Subject: Responses to Comments on the Scoping and Planning Documents
Lindsay Light II Site, Chicago, Illinois
Grant Correspondence Number 5022.006

**KERR-McGEE CHEMICAL CORPORATION
RESPONSES TO U.S. EPA REGION V
COMMENTS ON
SCOPING AND PLANNING DOCUMENTS**

**FOR THE
EXCAVATION AND RESTORATION PHASE
AT THE
LINDSAY LIGHT II SITE
CHICAGO, ILLINOIS**

**Figure 3.1 of the Health and Safety Plan
Impacted Areas of Lindsay Light II Site**

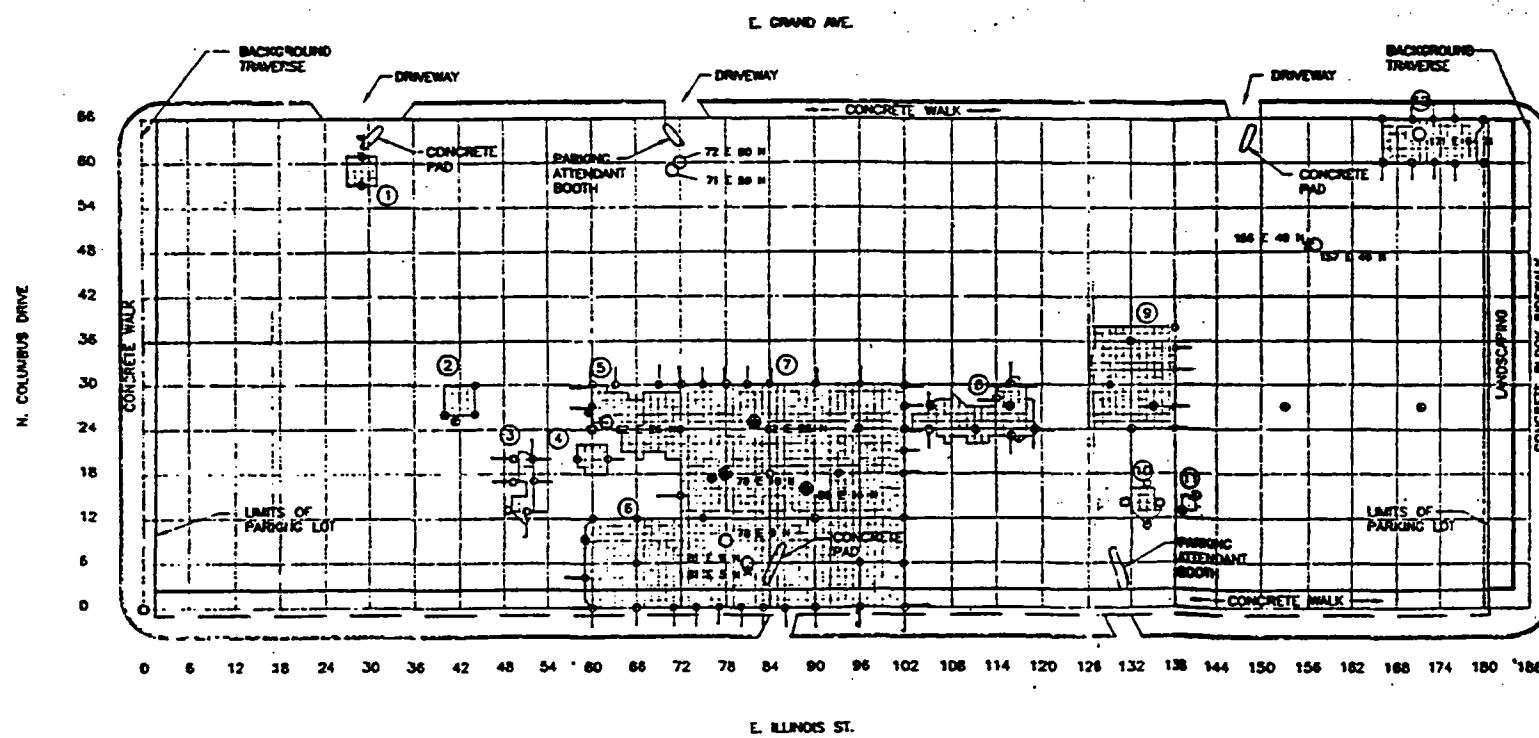
76. Document 400--Somewhere in this document you should include a detailed site map showing clean zone/support zone, decontamination zone and exclusion zone/hot zone. Also, the following statement should be included in this document - This plan will meet the requirements of OSHA 29 CFR 1910.120, Hazardous Waste Operations and Emergency Response, 1910 and 10 CFR. In addition, there should be a place for all workers, visitors to acknowledge their reading and understanding of the health and safety plan.

Response: The following information was added to the end of Section 3:

"Work zones will be established at the site. These zones include clean/support zones, decontamination zones, and exclusion zones. Although the clean/support zones are anticipated to remain fixed, other zones will move about the site as drilling and excavation work progresses. Figure 3.1 shows the impacted areas where exclusion zones may be established during excavation activities."

A copy of the figure is enclosed.
